Addendum No. 01

Subject: John Taggart ES – Classroom Modernization

SDP Contract Nos. B-047C, B-050C, of 2017/18

This Addendum, dated 9th of May, 2018, shall modify and become part of the Contract Documents for the work of this project. Any items not mentioned herein, or affected by, shall be performed strictly in accordance with the original documents.

DRAWING ED112 - THIRD LEVEL - LIGHTING FLOOR PLAN - DEMOLITION

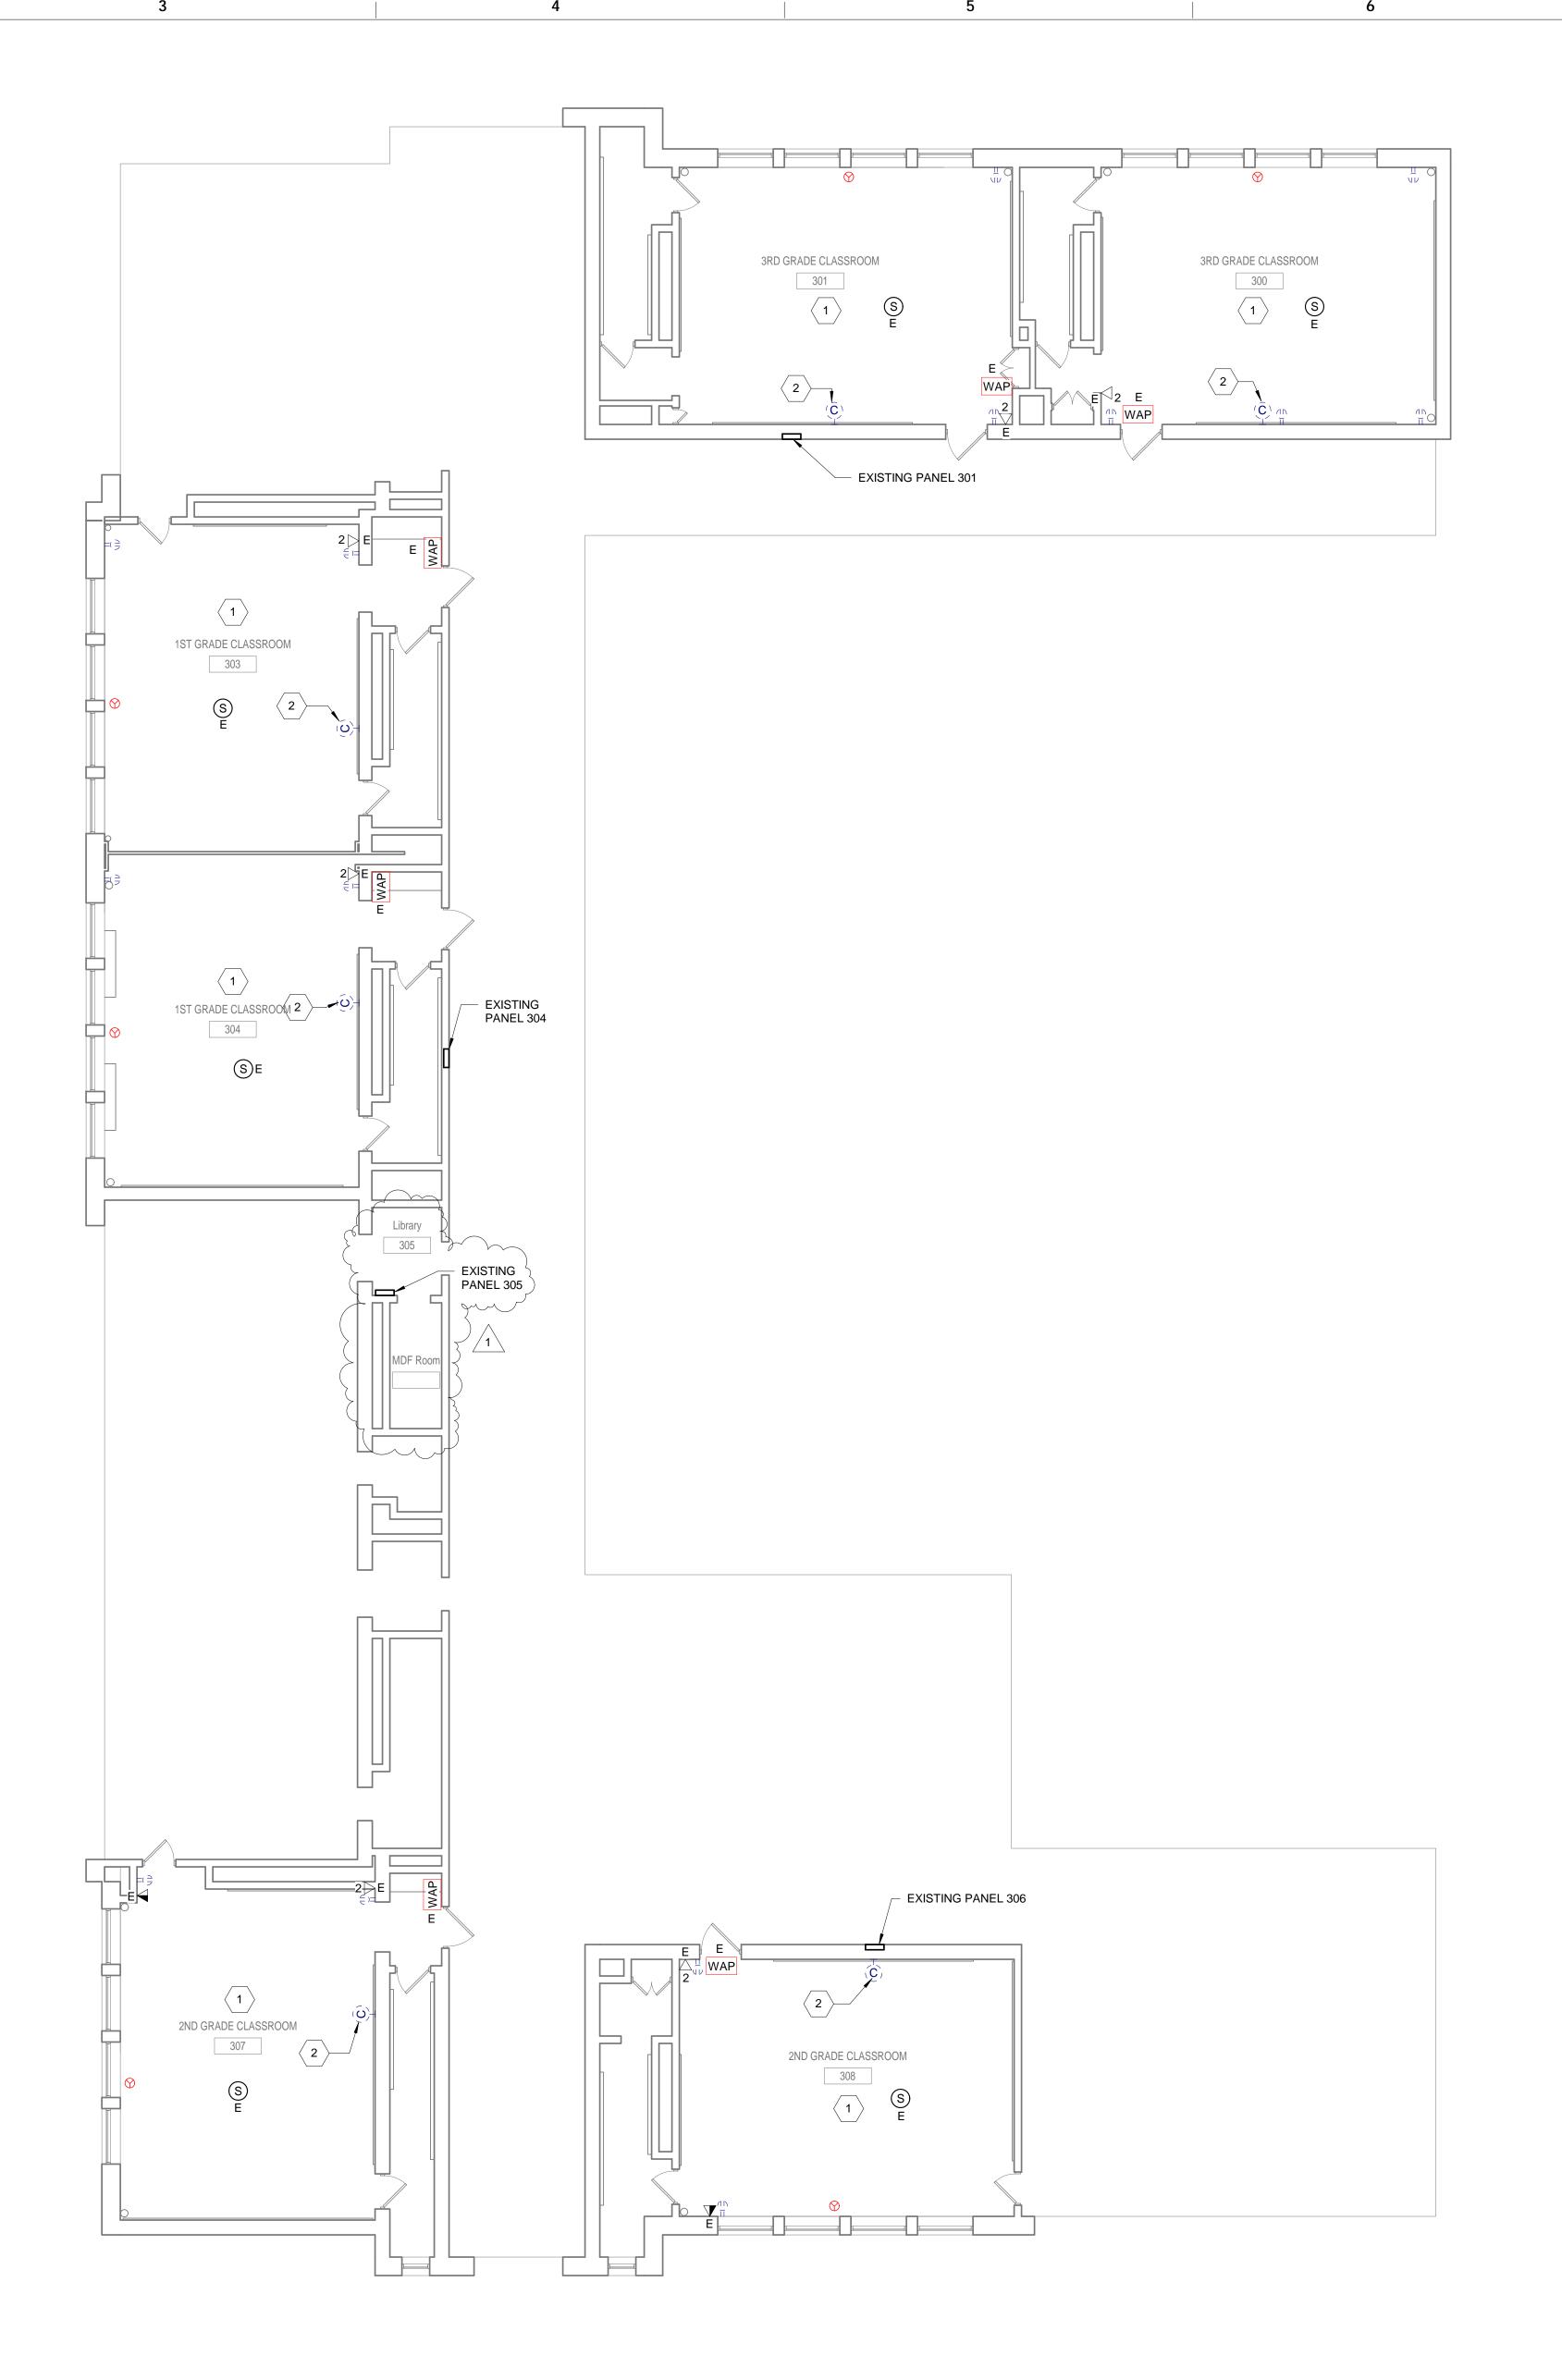
- 1. **ADD** existing lights in toilet and storage.
- 2. ADD MDF room 305.

DRAWING ED122 - THIRD LEVEL - POWER FLOOR PLAN - DEMOLITION

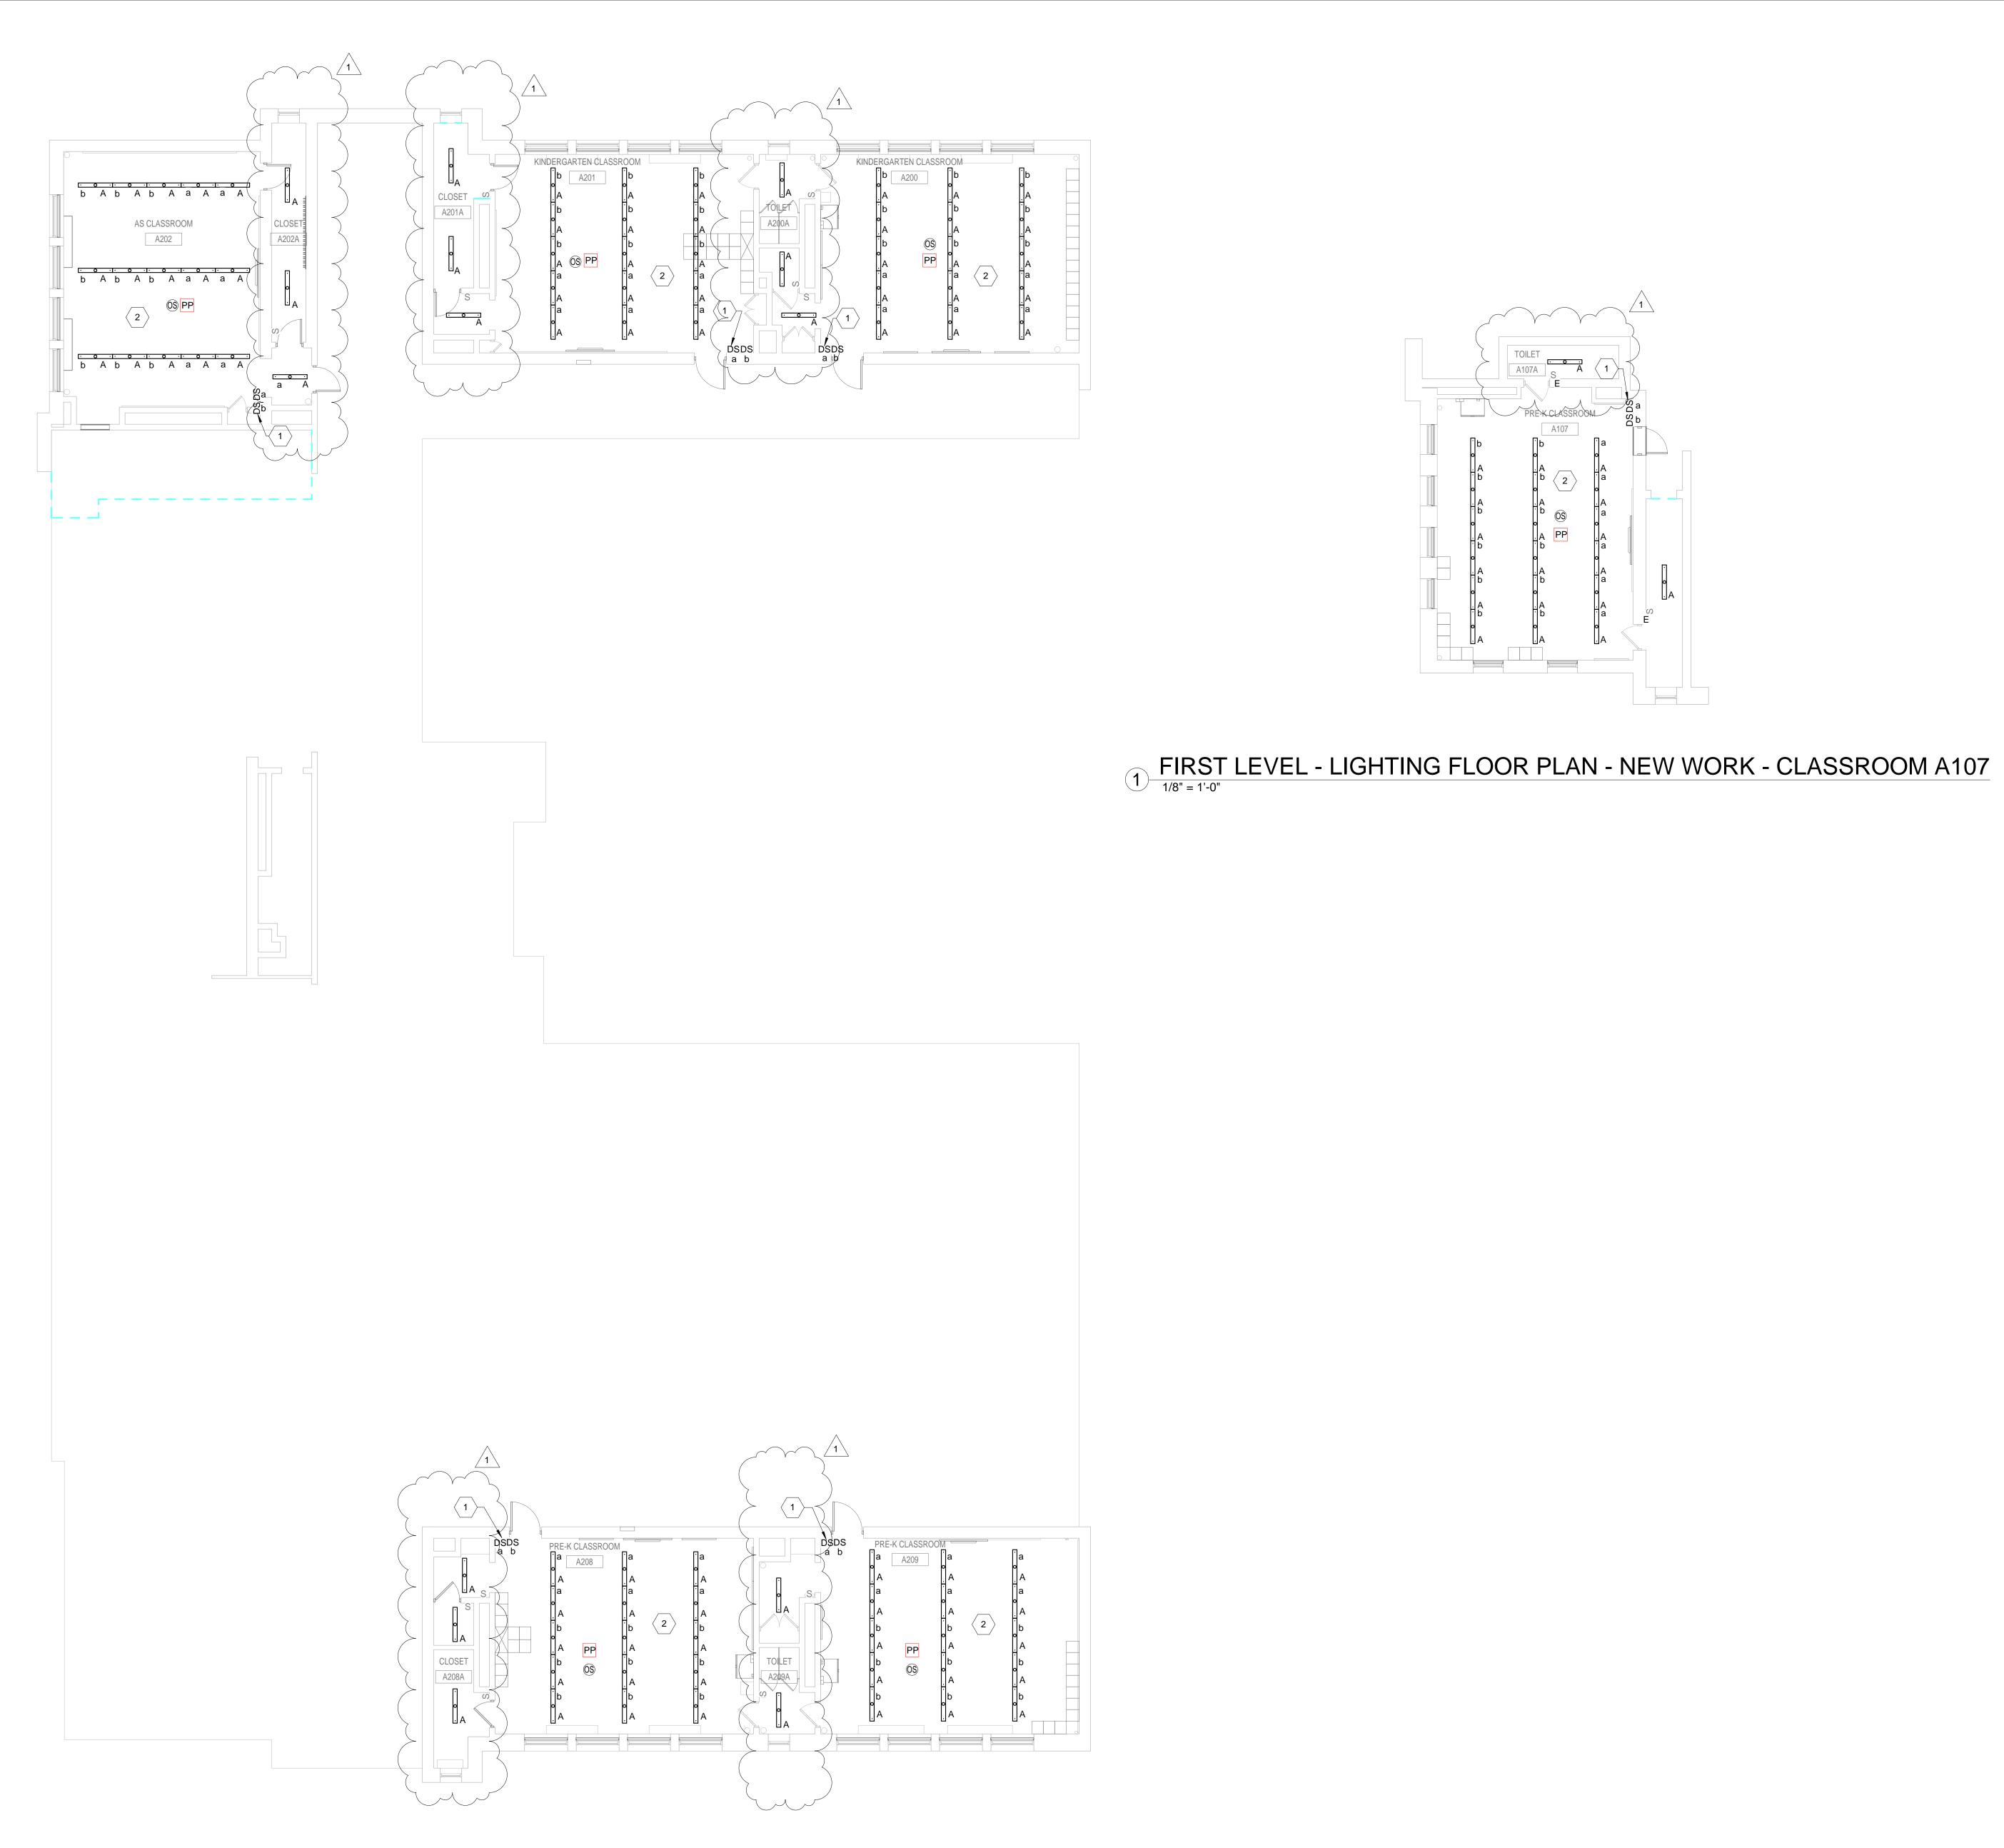
8. Question: Where is existing IT rack shown on the electrical floor plans?

1. **ADD** MDF room 305.

<u>Response:</u> Existing MDF Room is located in closet in room 305 Library. Please see Addendum 1 contract drawing ED122 and E122.

DRAWING E111 - FIRST & SECOND LEVEL - LIGHTING FLOOR PLANS - NEW WORK

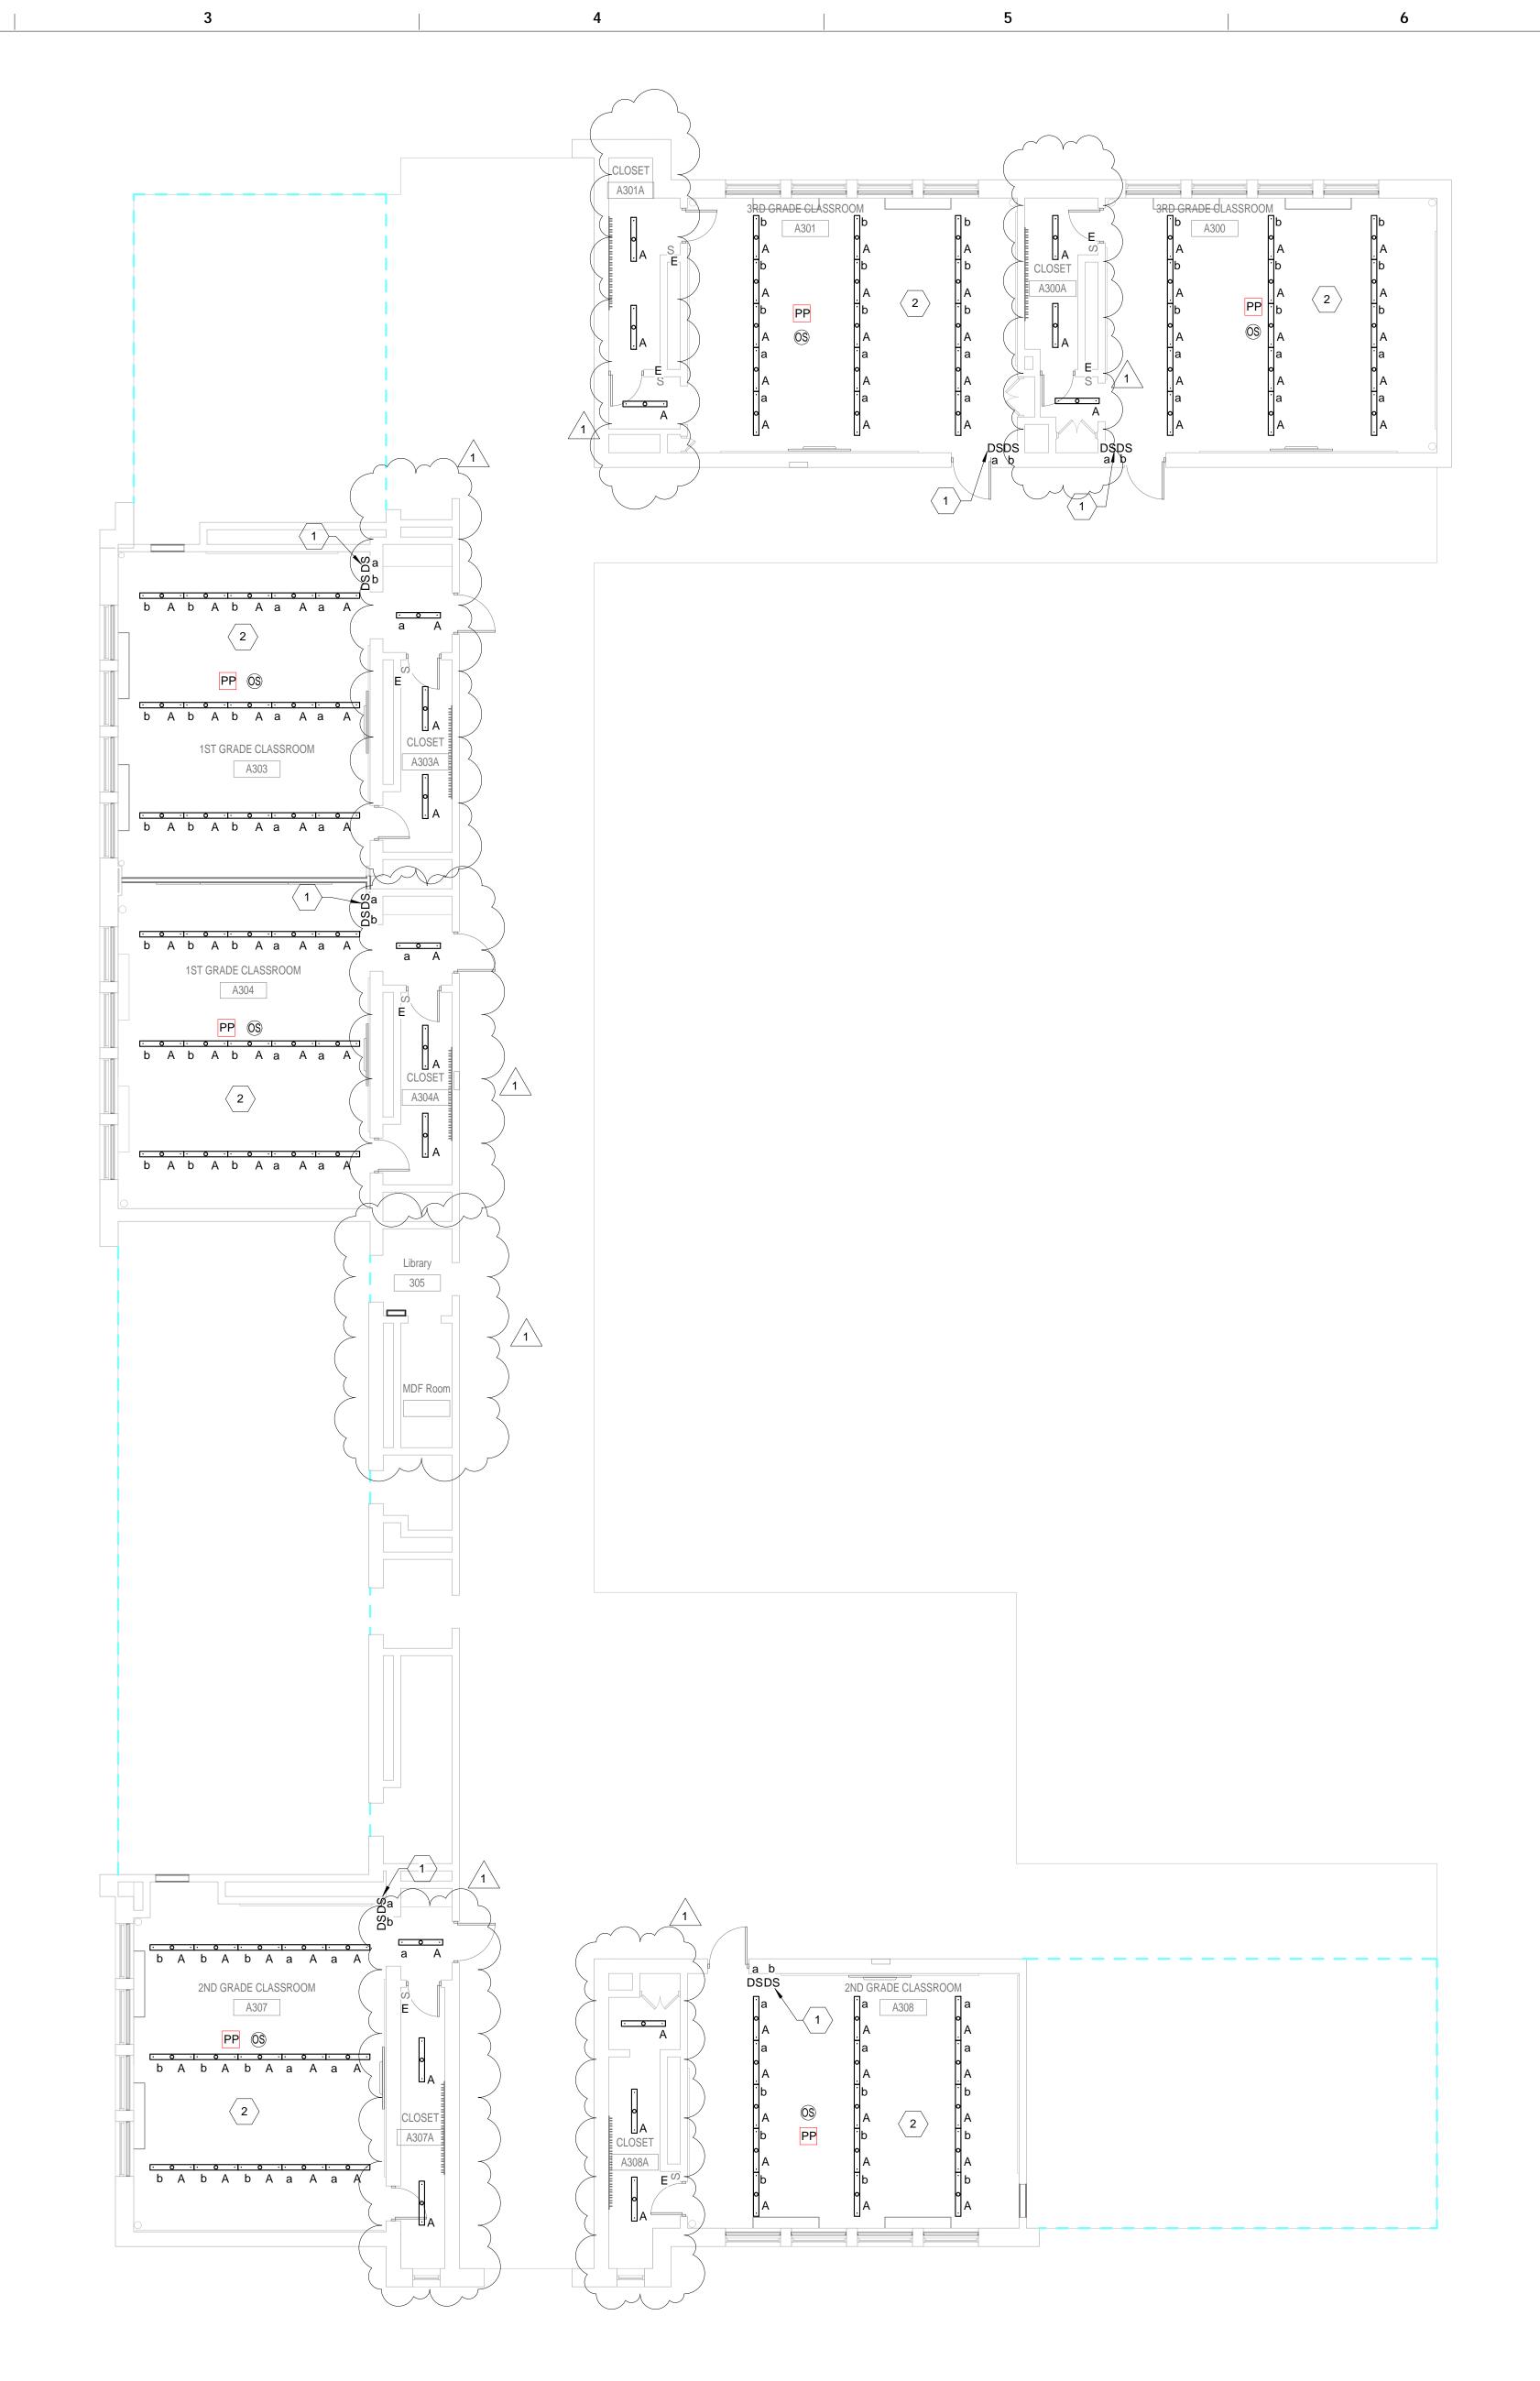
1. **ADD** new lights in toilet and storage.
